MODEL **238, 44**

### OIL TANK VENTILATION

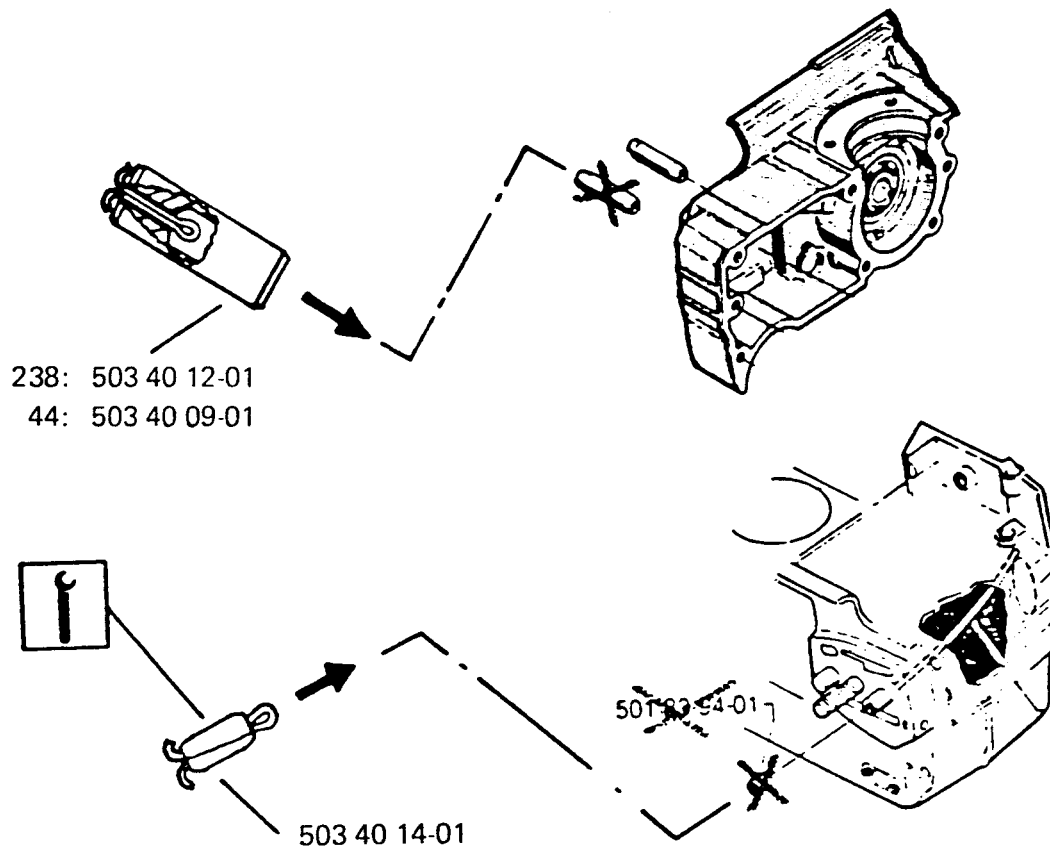
The tank ventilation, which consists of a sinter plug assembled in a roll pin, is excluded from our production.

In exchange, a new compl. tank ventilation will be introduced, which has a cotter pin mounted in a pin (see illustr. ).

A repair kit is available for already produced saws. It contains a roll pin and a cotter pin. The kit is assembled instead of the sinter plug (see illustr.).

The change was introduced from serial number:

238 G	6120909
238	6080480
44	6143222
